**CITY OF VANCOUVER
DEVELOPMENT, BUILDINGS, & LICENSING**

**DEVELOPMENT PERMIT STAFF COMMITTEE
MEETING
December 6, 2023**

**1050 Expo Boulevard (COMPLETE APPLICATION)
DP-2023-00629 – CD-1**

Figure 3. Building siting, orientation, tower floor plate, and tower separation

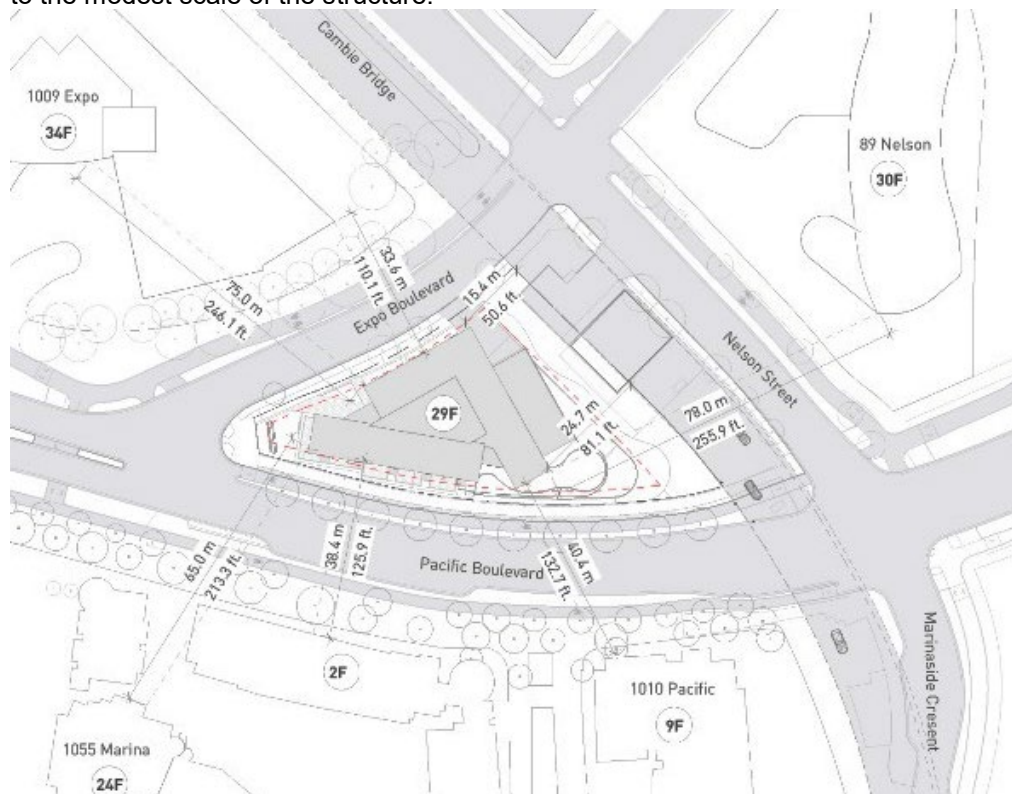
- A 15.4m setback from Cambie Bridge is provided except for one-storey parkade access structure having a setback of 10.3m from Cambie Bridge. See Figure 3.

Staff acknowledge that building parameters comply with the CD-1 Guidelines and reduced setback from Cambie Bridge for one-storey parkade access structure can be supported due to the modest scale of the structure.

Figure 4. Grade-Level uses and Site Constraints

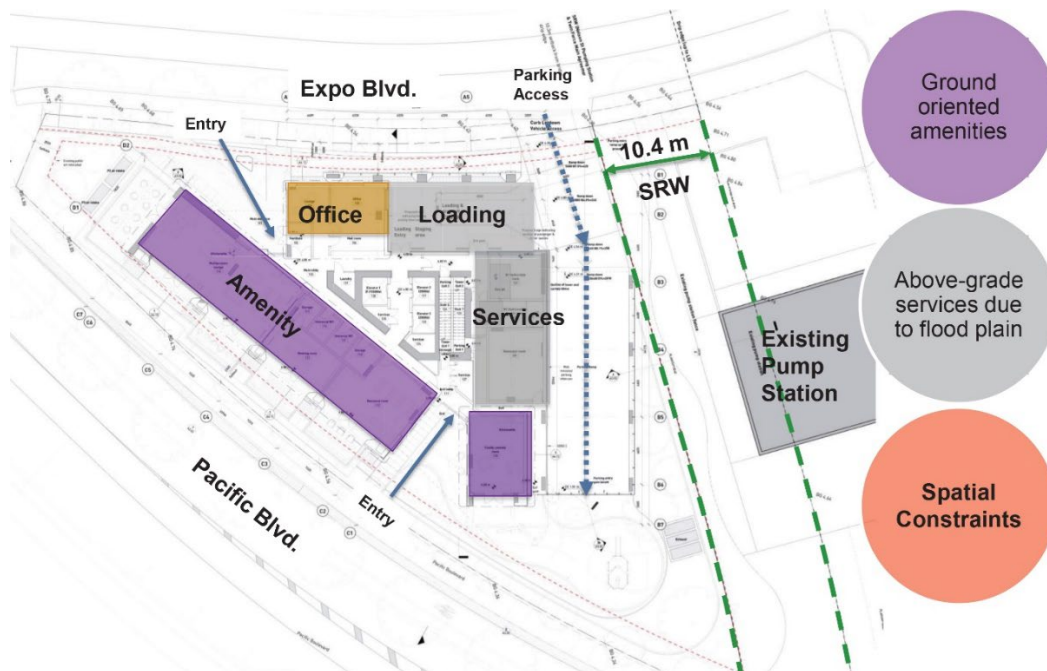
Applicant's Response: The proposed grade-level uses include indoor and outdoor amenities and building services. Providing non-dwelling uses at grade level is challenging and is rationalized as below (see Figure 4):

Staff acknowledge that grade-level Commercial and service uses are encouraged in the guideline and not required by the bylaw. The proposal is initially a housing proposal to accommodate vulnerable populations. The site has several constraints and is located downtown which is well served by non-dwelling uses and job spaces.

Figure 8. Projection into View Cone – Image 1

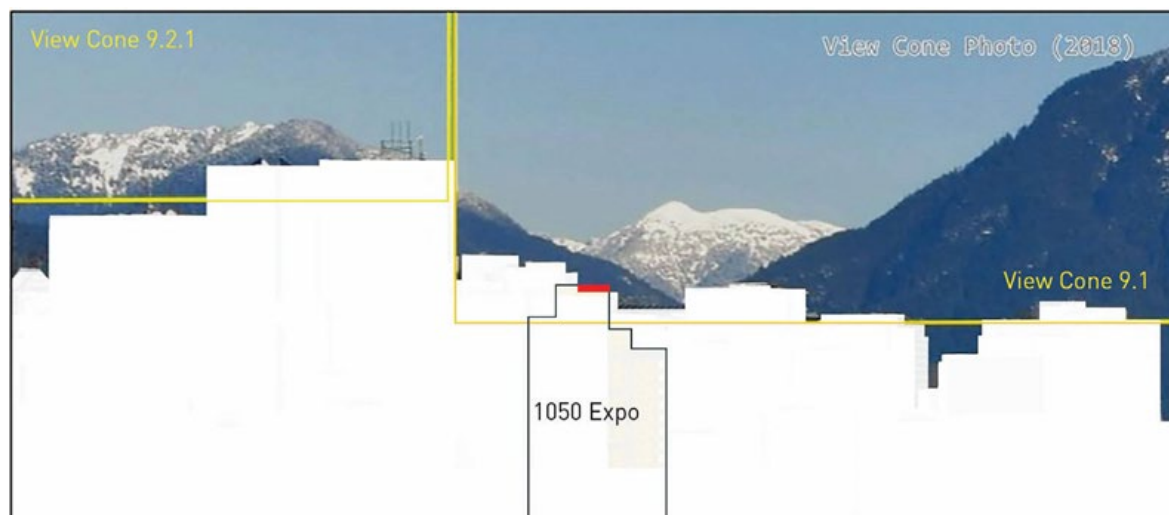
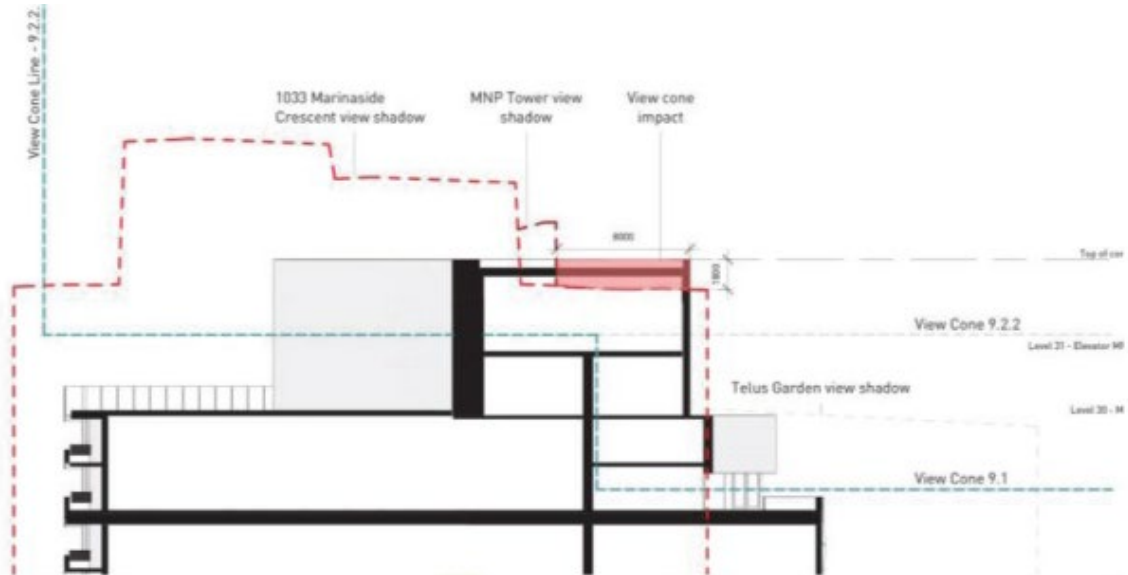
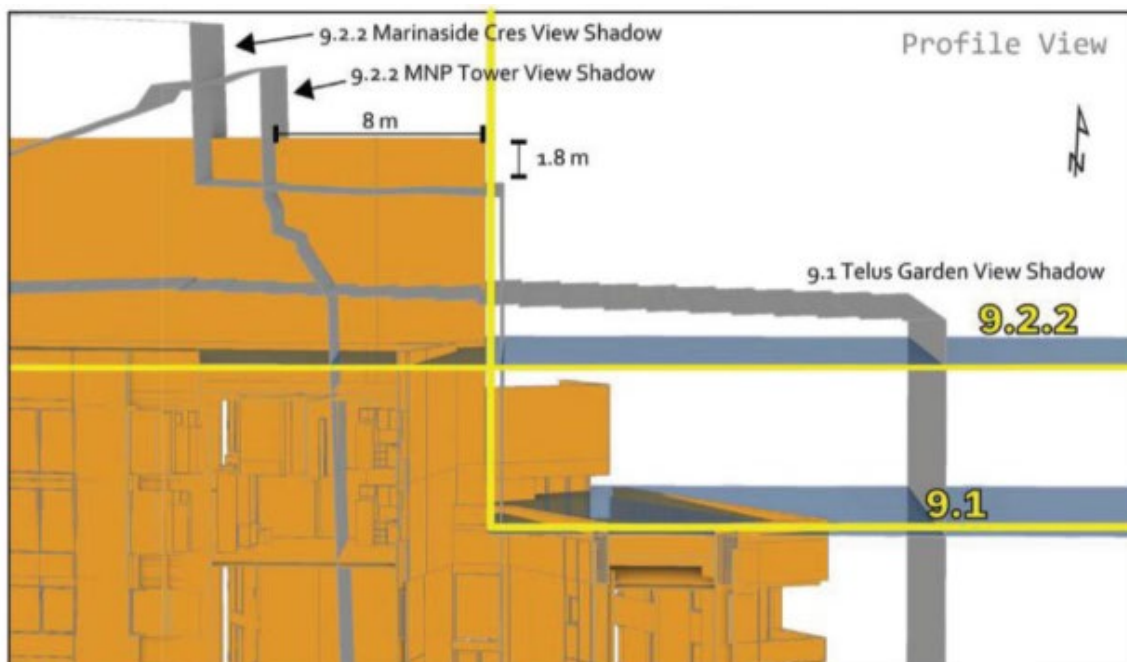
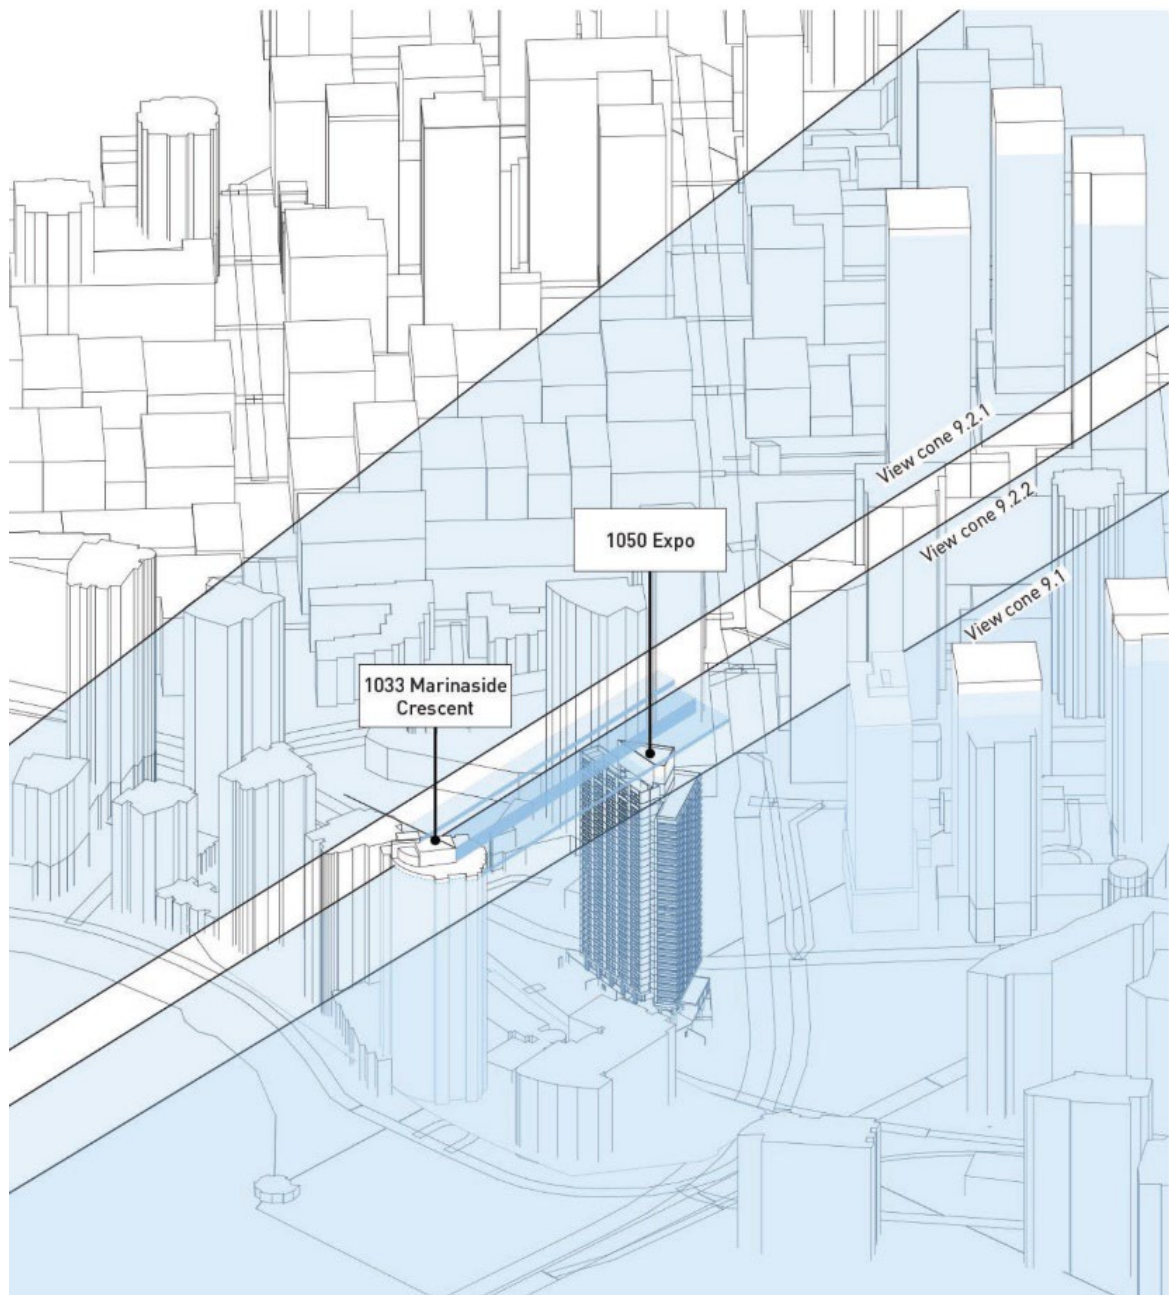
Applicant’s Response: Three view cones pass through the site, 9.1 (Cambie @10th/11th) – 9.2.1 (Cambie @12th) – 9.2.2 (Cambie @12th). The mechanical penthouse of the proposed building projects into view cones 9.1 and 9.2.2, however, most of the projection is covered by the view shadows of 1033 Marinaside Crescent and Telus Gardens buildings. The additional projection into view cone 9.2.2 is 1.8m high and 8m wide. See Figure 8.

The incremental impact of these incursions on the protected view, over and above the existing incursions by other developments, is negligible (shown in red in Figure 8). Staff acknowledge that the additional projection into view cone 9.2.2 is unavoidable due to the required height for the mechanical structure of the tower and the mandate to deliver 661 social housing units. The proposal provides high-quality units and amenities for residents and staff recommends support of the minor additional projection into the view cone.
